Work Order ID 88404

Item Name: Crosstube Aft

DART SERVICE INSTRUCTION

DRAWING NO. D212-664-241	TITLE CROSSTUBE ASSY (205/212 HI AFT)	REV. D	DART AEROSPACE LTD ENGINEERING ORDER		D.E.O. NO. D212-664-241-D-1	SHEET NO. SHEET 1 OF 2	SCALE NTS
DRAWN	CHECKED	MFG. APPR.	APPROVED	DE APPR.			
DATE 11.04.07	DATE 11.04.11	DATE 11.04.12	DATE 11/04/12	DATE 11.04.12

FIGURE 1: SUPPORT INSTALLATION

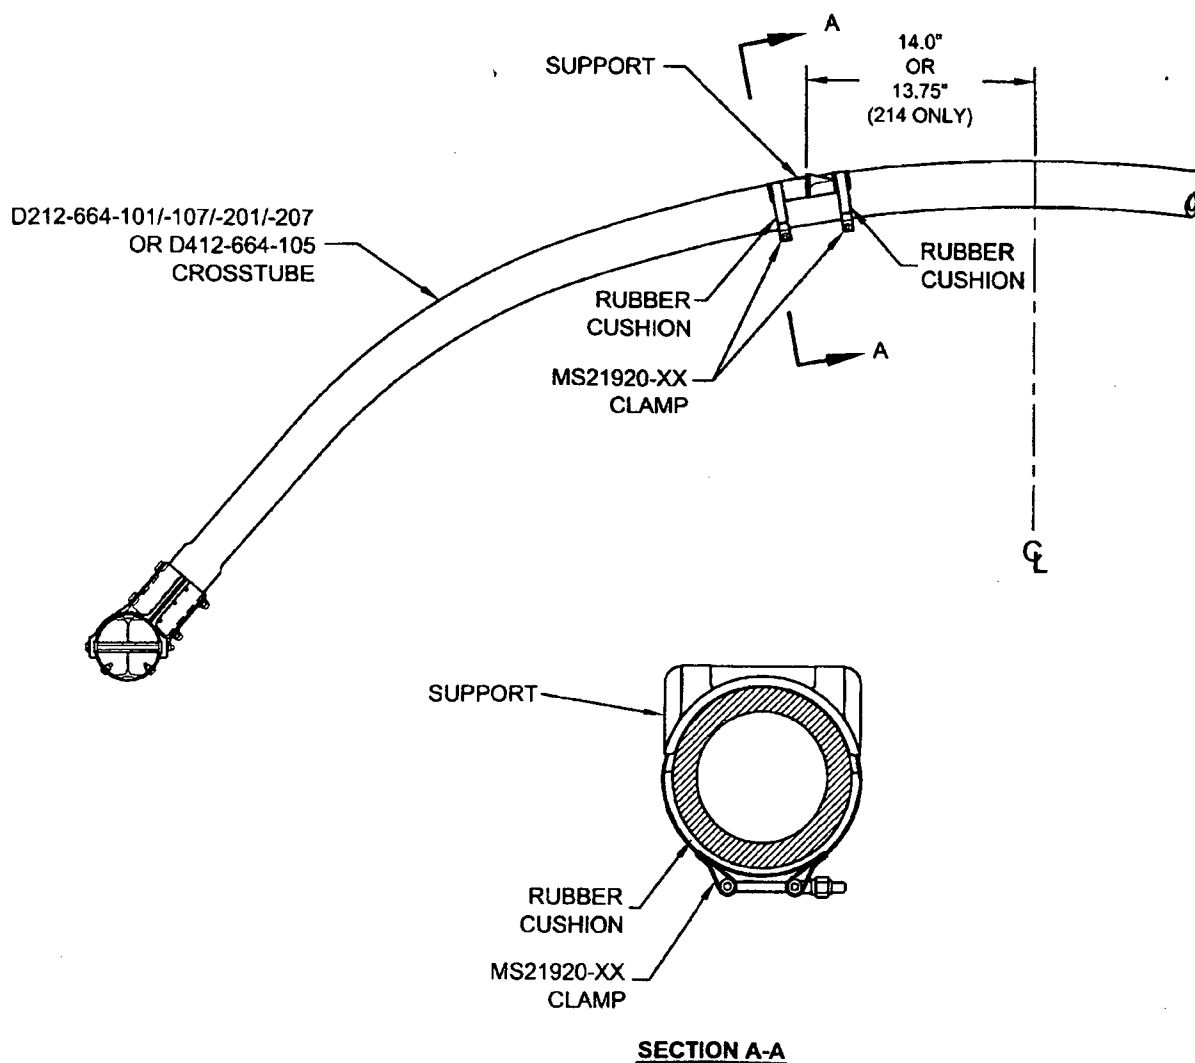
The supports on the following crosstubes are now installed using Proseal instead of Magnobond:

For the crosstubes listed above, section 32.4 of ICA-D212-664 is amended as follows. Use Figure 1 of this service instruction and Figures 32-2 to 32-9 of ICA-D212-664 for further reference. For crosstubes of an earlier change number, it is recommended that if the supports are removed, the supports should be reinstalled using the procedure listed below.

- 32.4.5 Apply a 0.04" to 0.07" thick layer of Proseal 890 Class B or AMS-S-8802 Class B sealant underneath applicable support and install support as shown in Figure 1 of this service instruction.

- 32.4.6 Install the clamps opposite to crosstube support as shown in section A-A of Figure 1. Install rubber cushions underneath each clamp around the bottom circumference of the crosstube up to the crosstube centerline. Torque clamps 80-100 in-lb (9.0-11.3 Nm). It is acceptable to use smaller or larger sized MS21920-XX clamps than those listed in ICA-D212-664, ensure that after torquing the clamps per this instruction, the nuts are in safety but not bottomed out

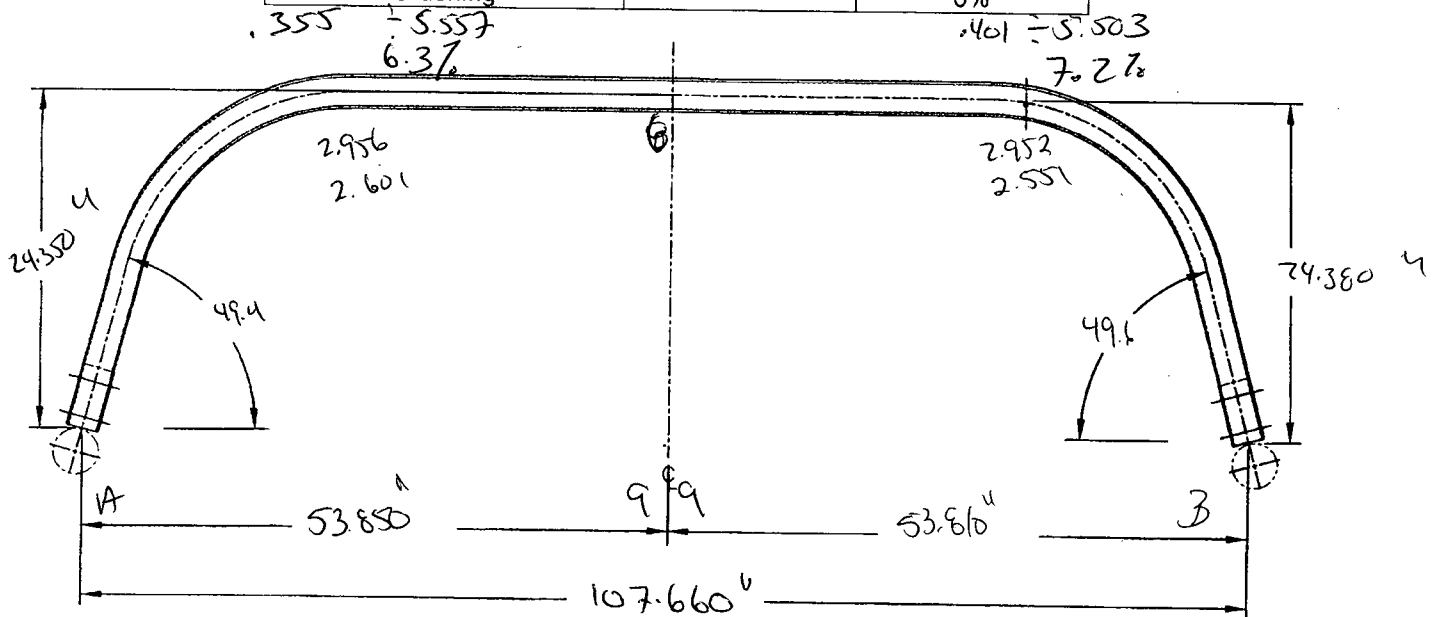
Side A	middle	Side B
Bending Passes	9	6	9
Crushing	6.3%		7.2%
Comments			
Side A = 6.3% crushing @ 9 Passes			
middle = 6 Passes			
Side B = 7.2% crushing @ 9 Passes

CRUSHING OF D212-664-201

Acceptability of 8% CRUSHING

The will fail at support before area of 8% CRUSHING. 8% CRUSHING AT END OF BEAM IS ACCEPTABLE

$MS = 14.32 / 11.65 - 1 = 0.22$

D212-664-241/-241B
ASSEMBLY DETAIL

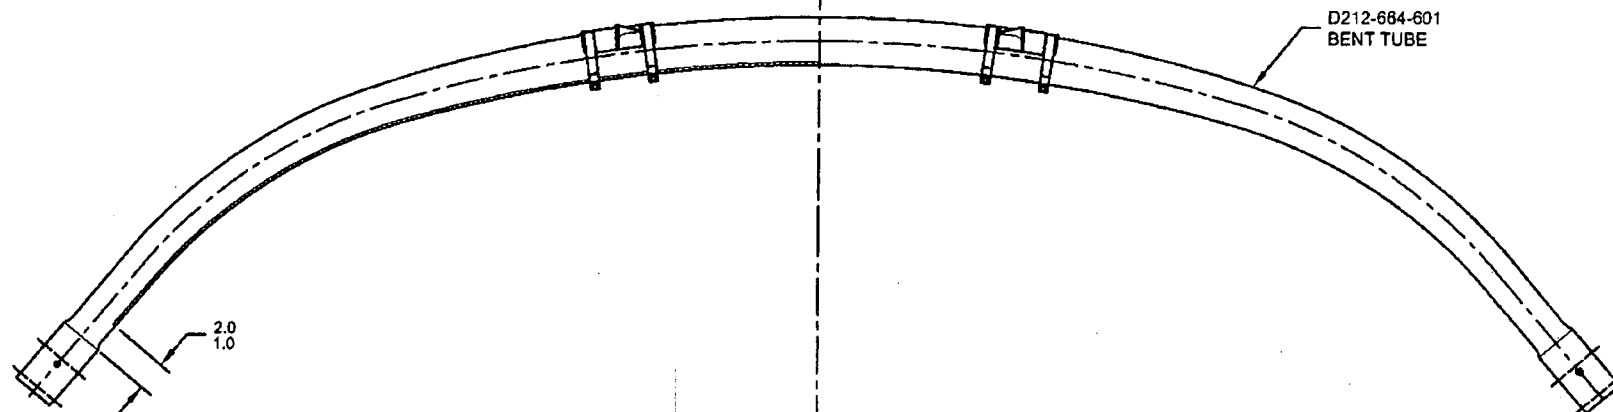
PURPOSE:

ADD AN INSPECTION WINDOW TO UNDERSIDE OF CROSSTUBE.

NOTES 2 OF SHEET 1 IS AMENDED AS FOLLOWS:

- 2) FINISH: CHEMICAL CONVERSION COAT PER DART QSI 005 4.1
PRIME INSIDE AND OUTSIDE PER DART QSI 005 4.2
MASK UNDERSIDE OF CROSSTUBE AS SHOWN (HATCHED AREA) AND
PAINT OUTSIDE PER DART QSI 005 4.2
REMOVE MASKING AND APPLY CLEAR COAT

MASK AREA PRIOR TO PAINTING,
REMOVE MASKING AFTER PAINT
AND APPLY CLEAR COAT

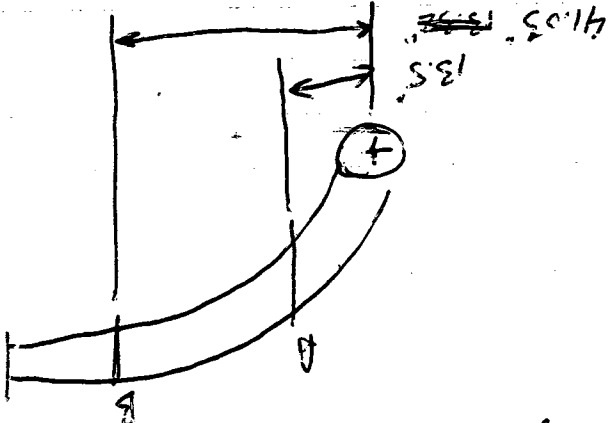
PURPOSE:

REPLACE MAGNOBOND WITH PROSEAL.

NOTE 12 & 15, SHEET 1 IS AMENDED AS FOLLOWS:

Item	Qty -241	Qty -241B	Part Number	Description
7	A/R	A/R	PROSEAL 890 B-2	SEALANT, AMS-S-8802 CLASS B-2

- 12) TO INSTALL D2940-1 SUPPORT: ABRASE MATING SURFACE OF SUPPORT AND CROSSTUBE WITH 180-GRIT SANDPAPER AND REMOVE RESIDUE WITH MEK (OR EQUIVALENT). APPLY A 0.04" TO 0.07" THICK LAYER OF PROSEAL 890 CLASS B-2 (OR AMS-S-8802 CLASS B-2) SEALANT TO MATING SURFACE OF SUPPORT.
- 15) TORQUE CLAMPS 80 TO 100 IN-LB. ENSURE AT LEAST 1.5 THREADS SHOWING IN SAFETY AND THAT NUT HAS NOT BOTTOMED-OUT AFTER TORQUING. **PRIOR TO PACKAGING, RE-CHECK TORQUE ON CLAMPS AFTER PROSEAL 890 SEALANT HAS CURED FOR 72 HOURS.**
